REVISION	DESCRIPTION	DATE
A	DEVELOPMENT APPLICATION	09/2020
B	DA AMENDMENTS 1. First floor plan reconfigured with the rear first floor setback increased by 2.365m to ensure compliance with the maximum 10m Building Height limit. 2. The width of the first floor balcony has been reduced and the storage area at the rear of the carport has been deleted.	03/2021

PROPOSED DWELLING HOUSE
FOR
WILLIAM & NANCY GROUNDS

ADDRESS
13 PACIFIC ROAD PALM
BEACH, NSW, 2108 LOT NO.
404 | DP NO. 19651

View Impact Analysis from number 11 Pacific Road, Palm Beach. This view is taken from the middle level deck area.

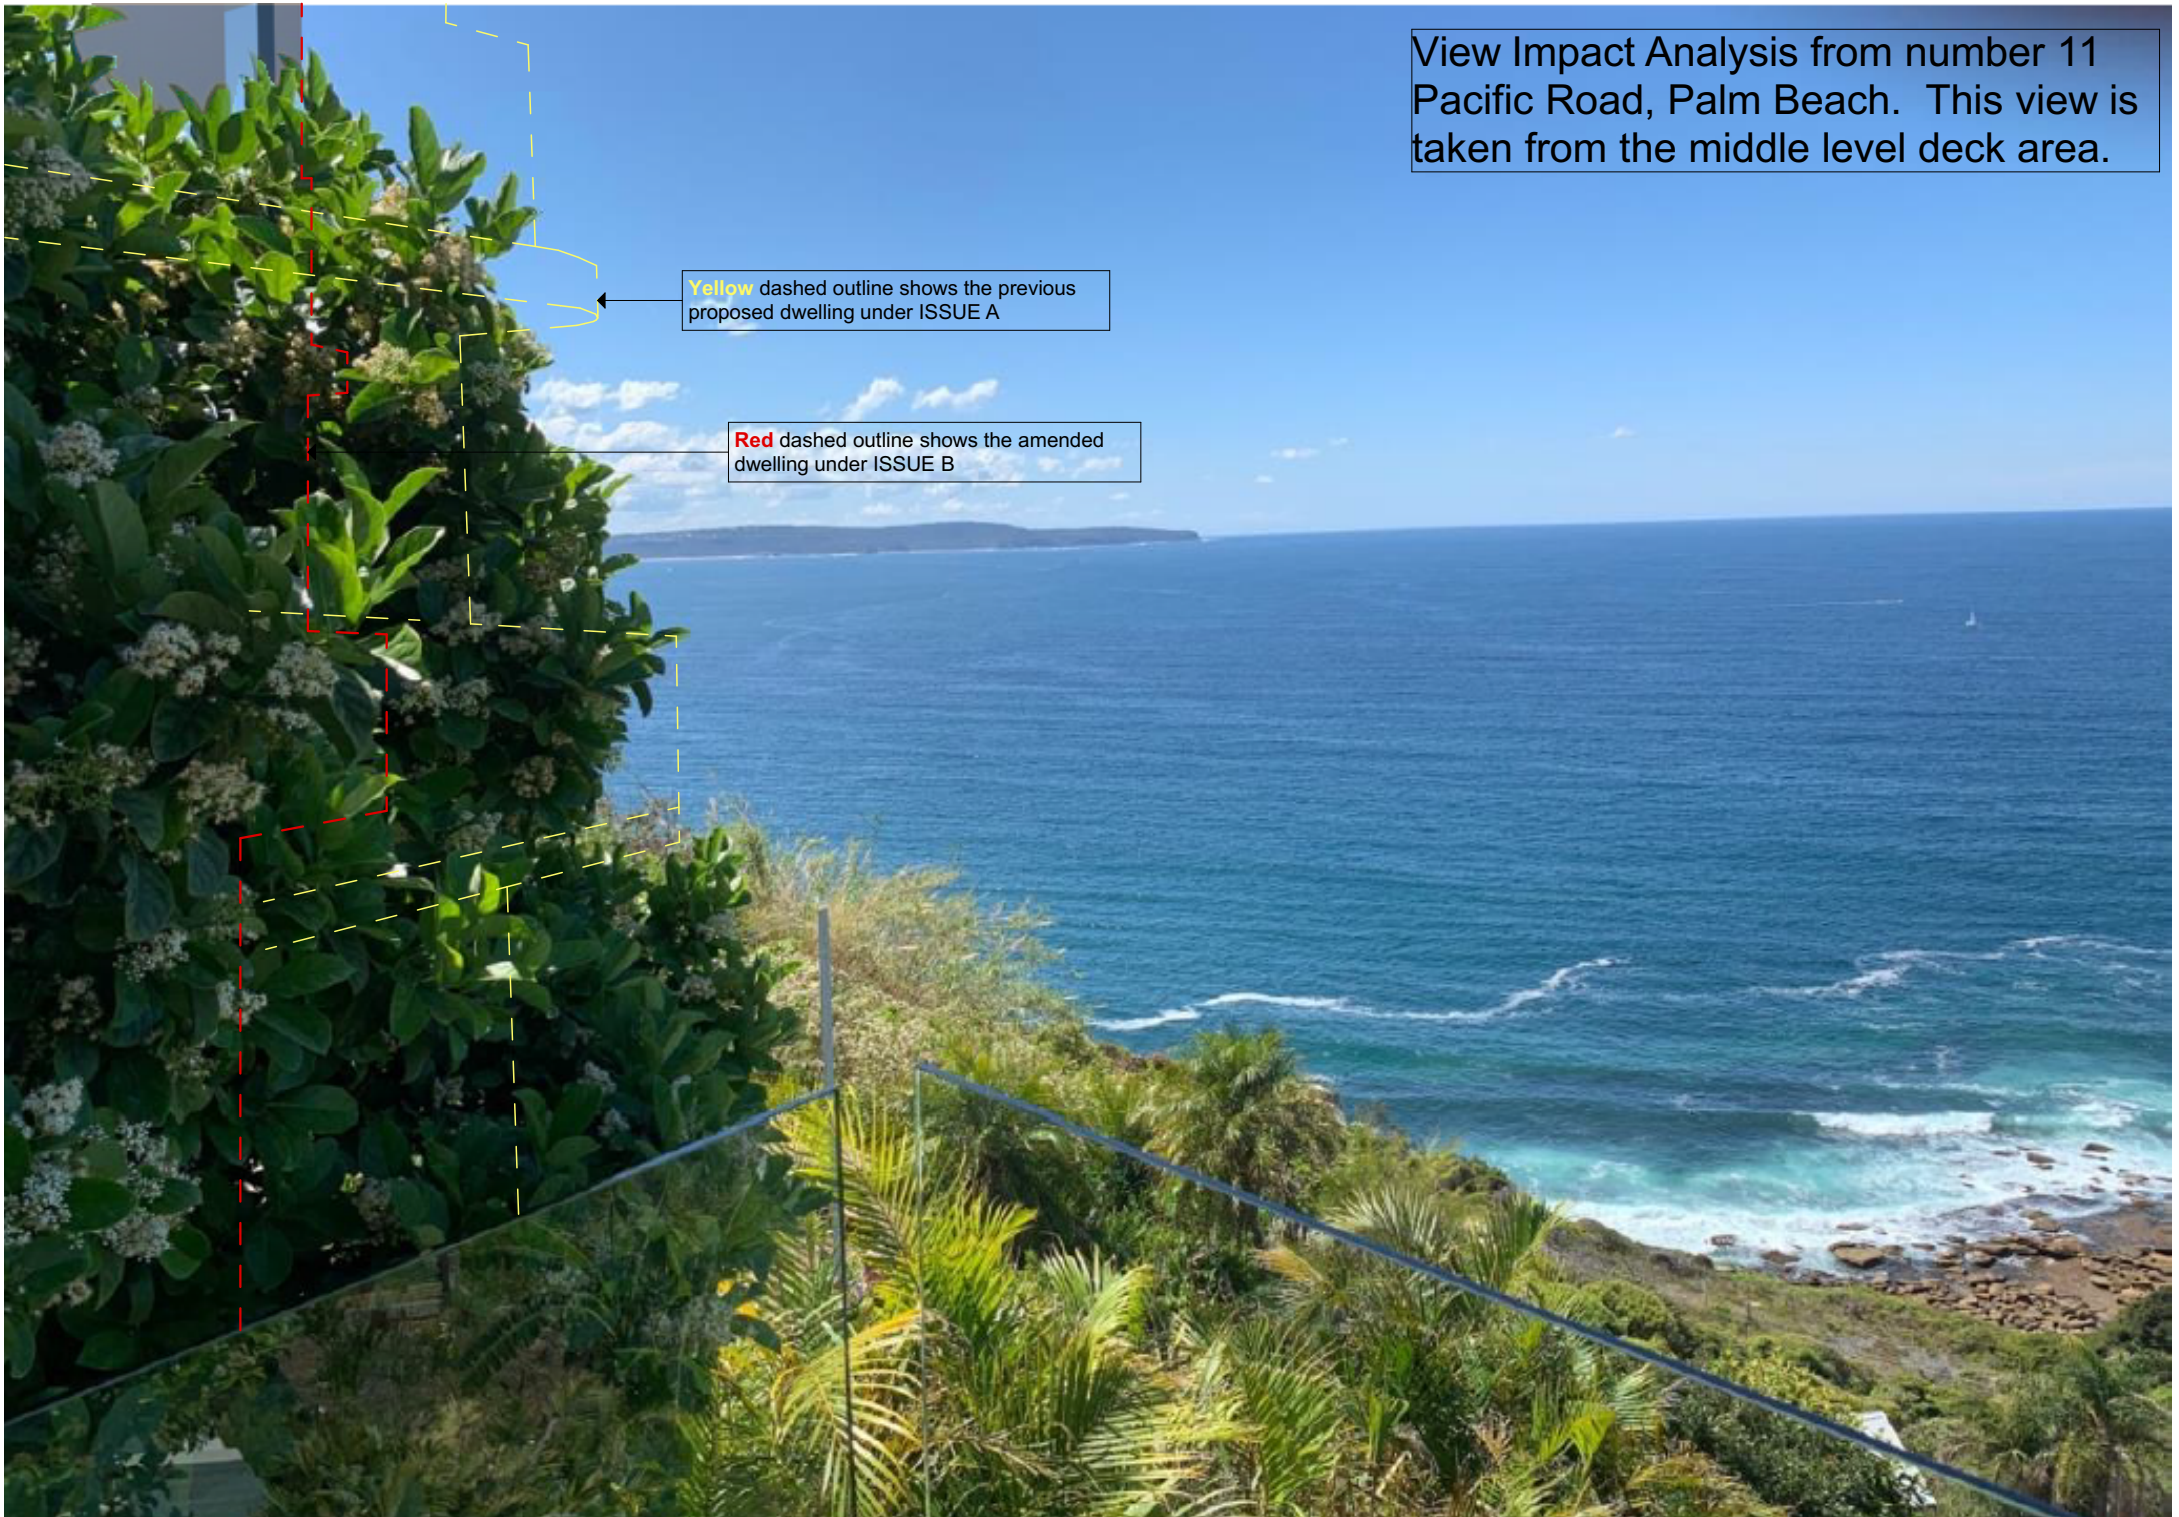
Yellow dashed outline shows the previous proposed dwelling under ISSUE A

Red dashed outline shows the amended dwelling under ISSUE B

View Impact Analysis from number 11 Pacific Road, Palm Beach. This view is taken from the upper bedroom.

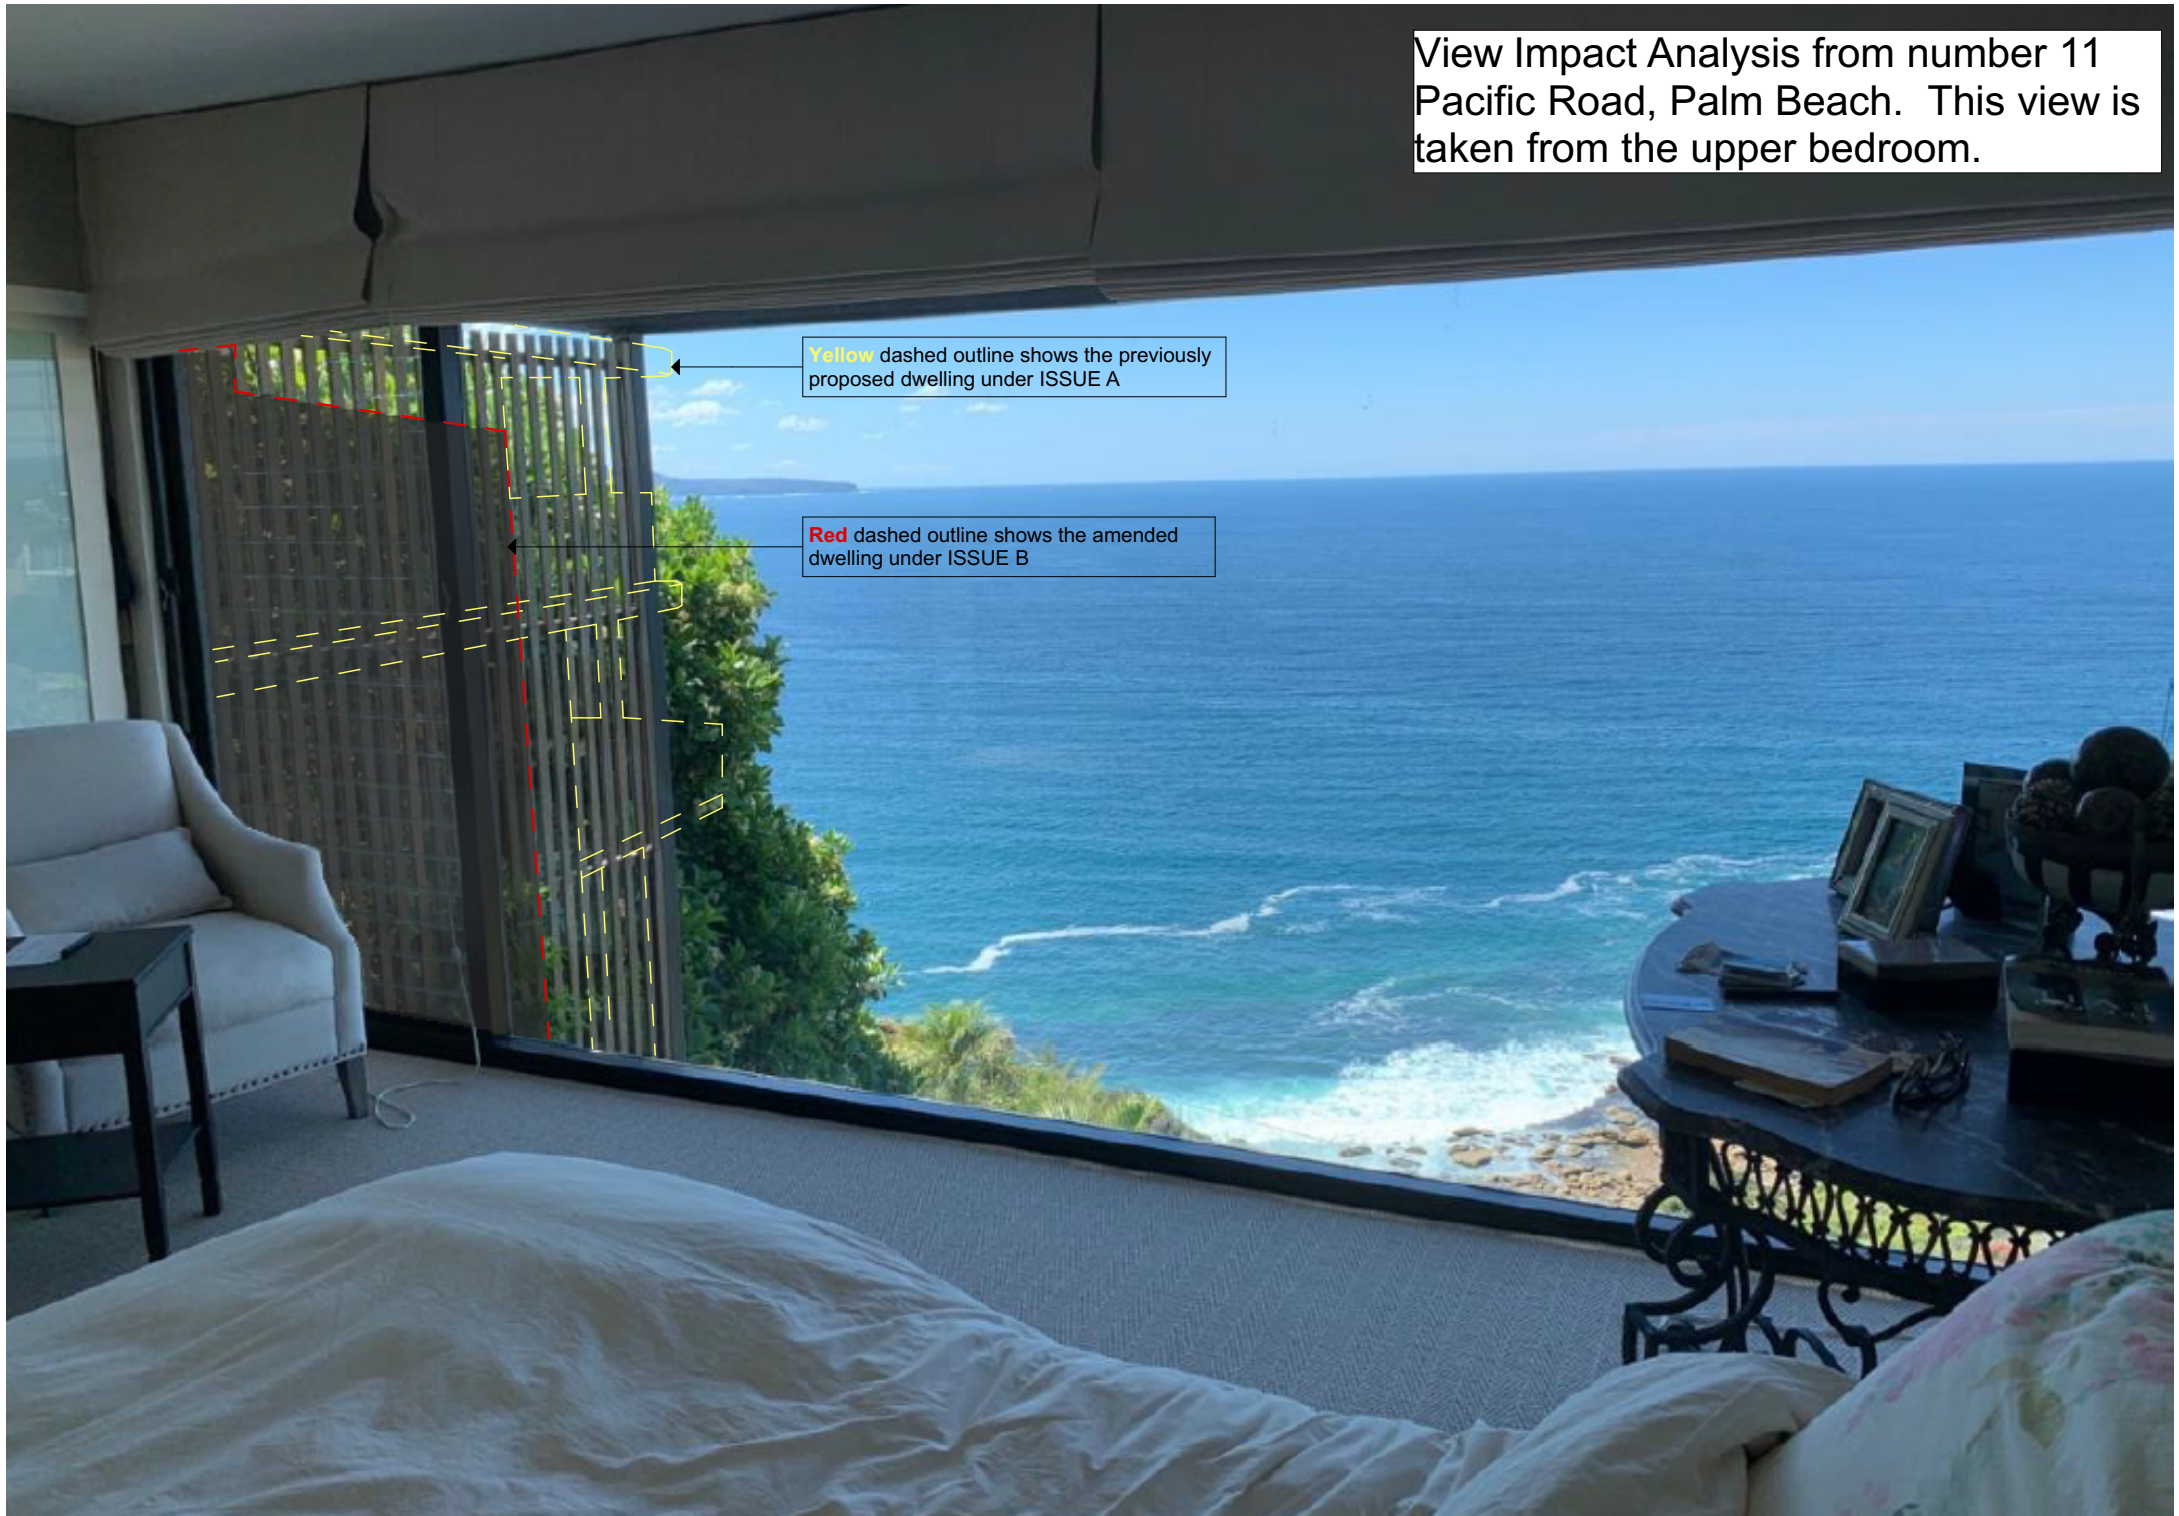
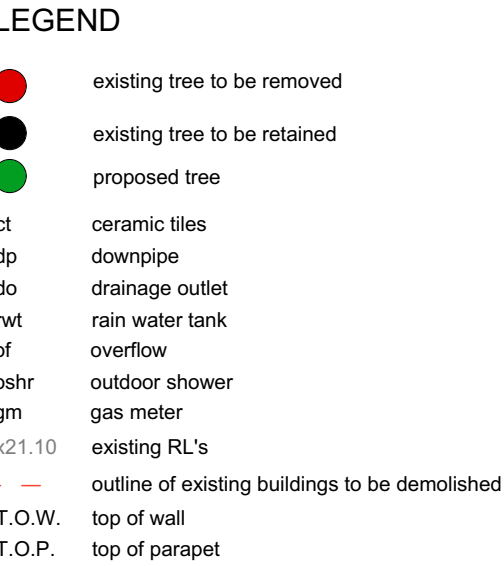
Yellow dashed outline shows the previously proposed dwelling under ISSUE A

Red dashed outline shows the amended dwelling under ISSUE B

LOWER GROUND FLOOR
PLAN

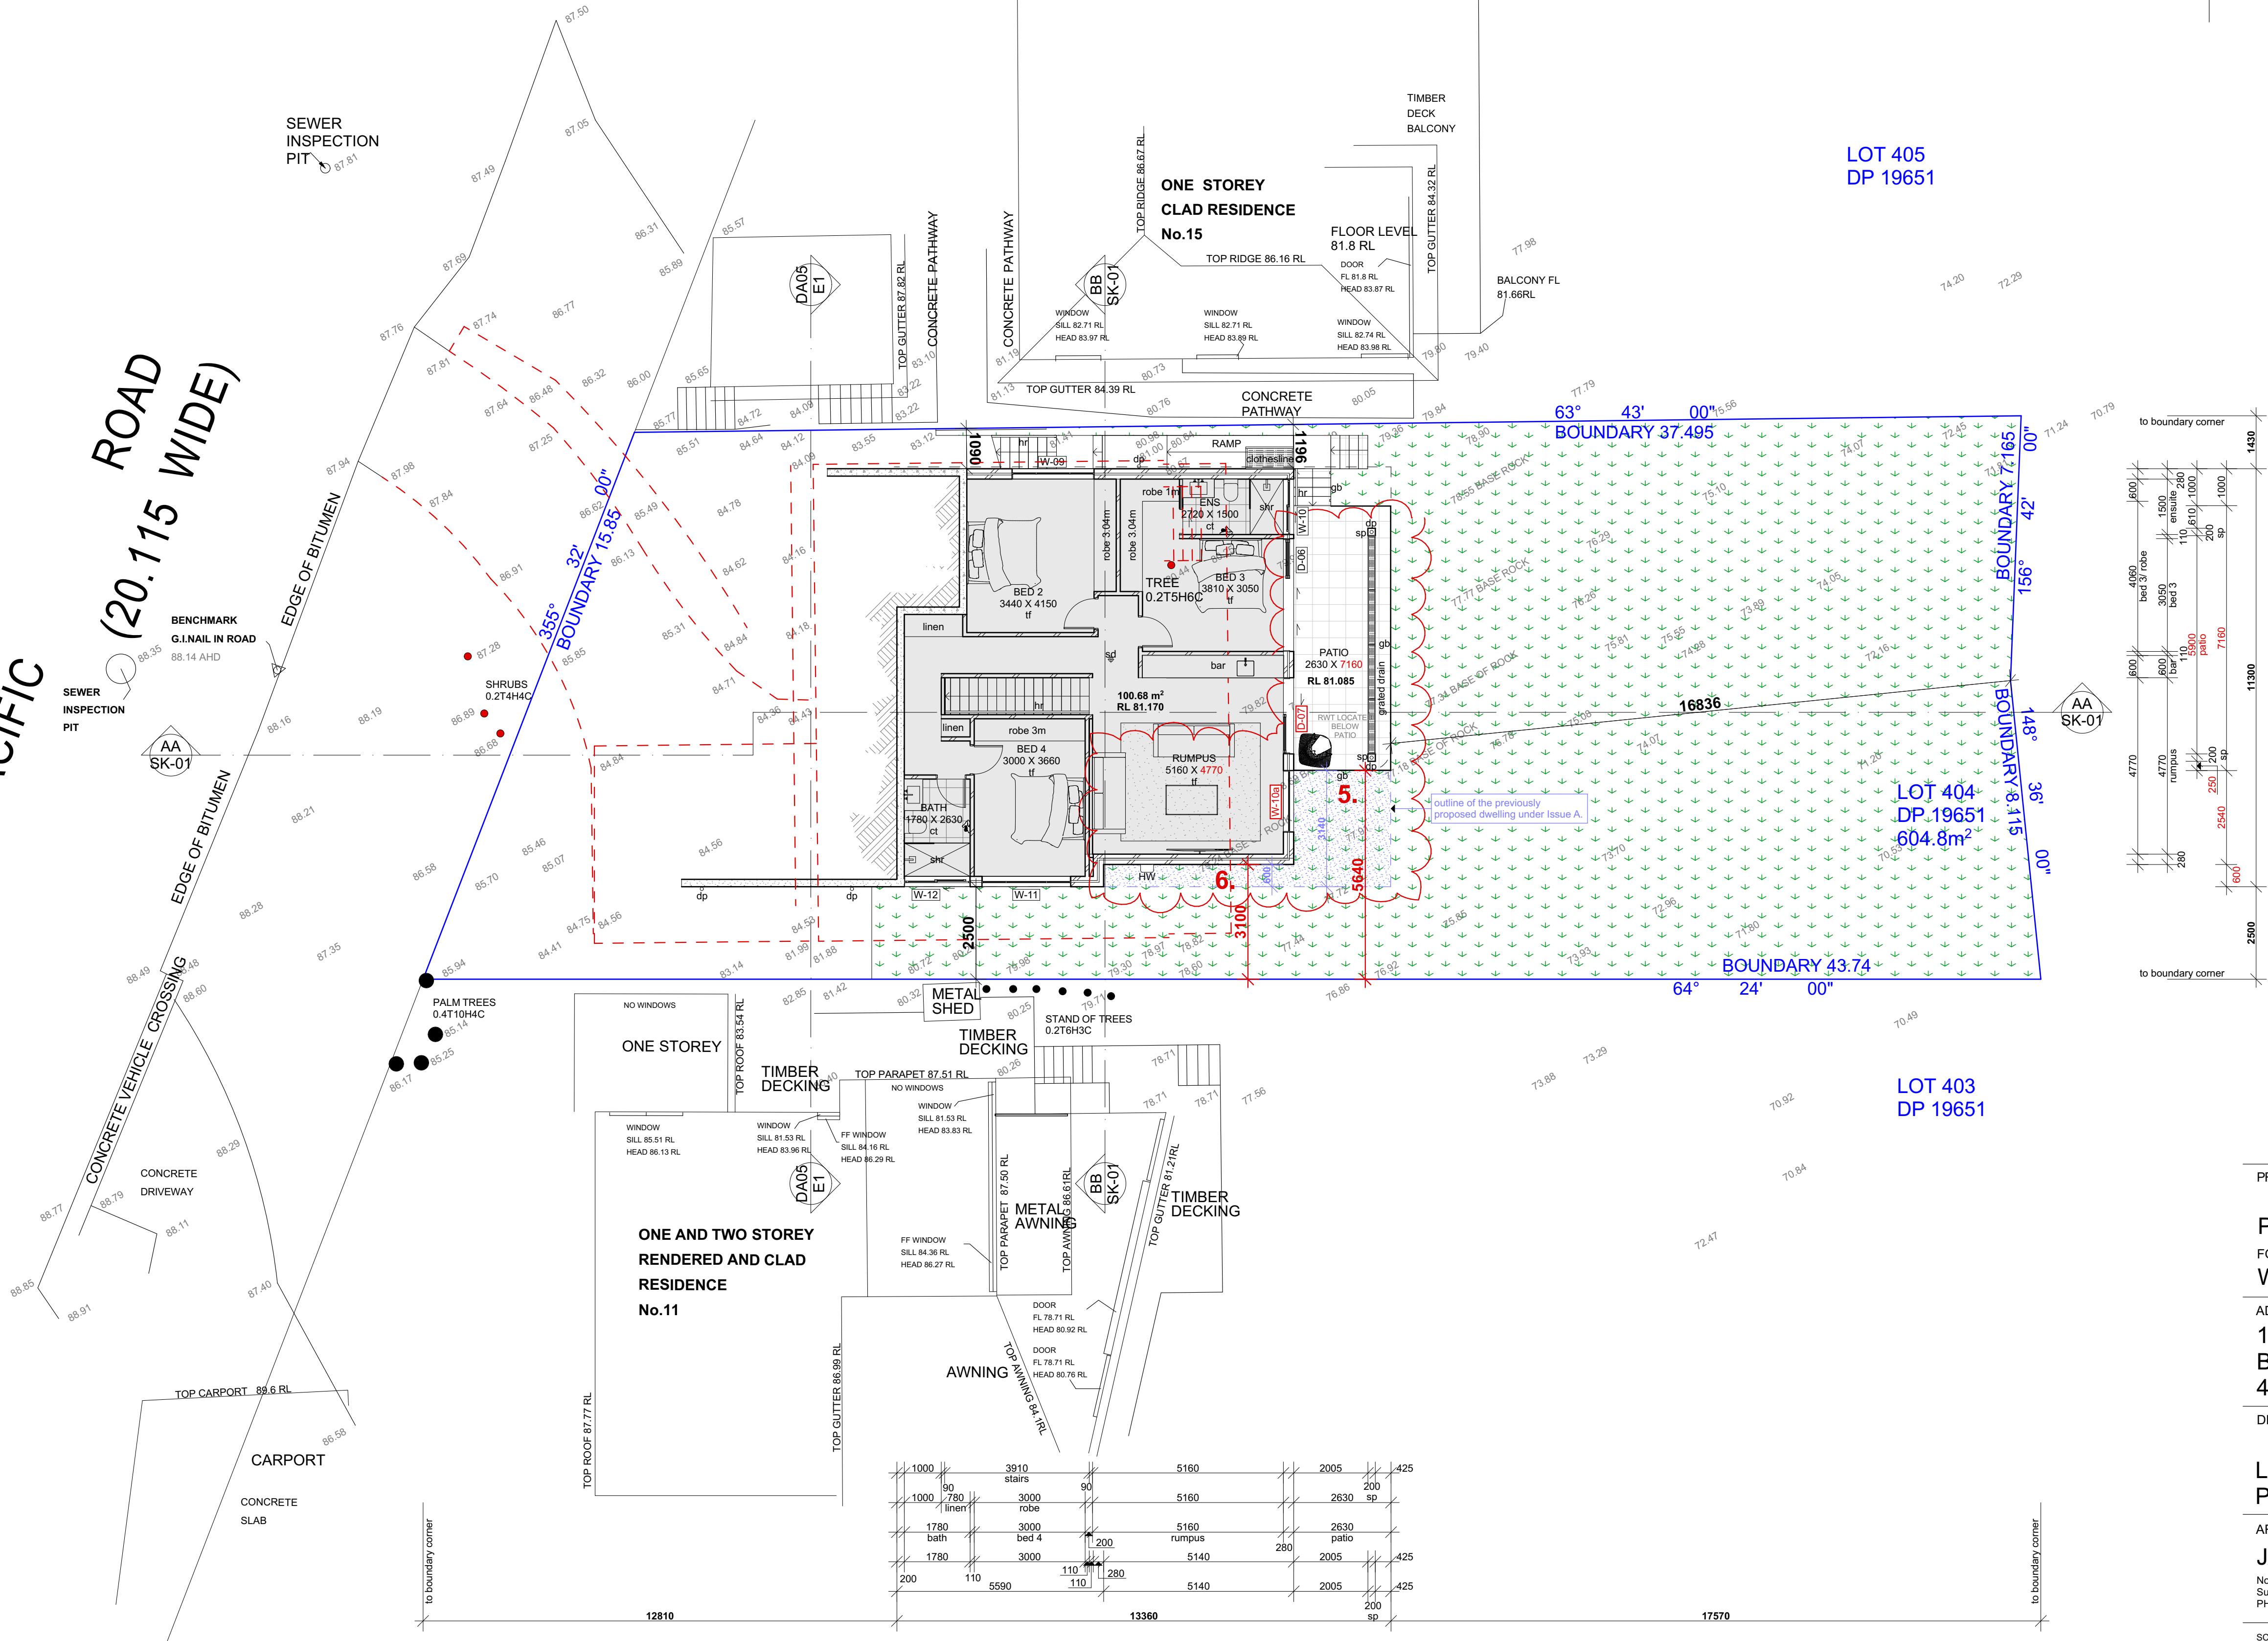
REVISION	DESCRIPTION	DATE
A	DEVELOPMENT APPLICATION	09/2020
B	DA AMENDMENTS 1. First floor plan reconfigured with the rear first floor setback increased by 2.355m to ensure compliance with the maximum 10m Building Height limit. 2. The width of the first floor balcony has been reduced and the storage area at the rear of the carport has been deleted. 3. The non trafficable portion of the first floor balcony has been removed to comply with the maximum 10m Building Height limit. 4. The carport roof over the proposed driveway has been reduced in length by 4.505m to comply with the maximum 10m Building Height limit. 5. The southern portion of the ground floor and lower ground floor balconies shown hatched on plan have been removed. 6. The ramp on the lower ground floor has been setback a further 600mm from the southern side boundary. 7. The southern external wall of the WC and Butlers Pantry on the ground floor have been aligned with the external walls above and below. 8. The southern side solid driveway has been replaced with an open form fence.	03/2021
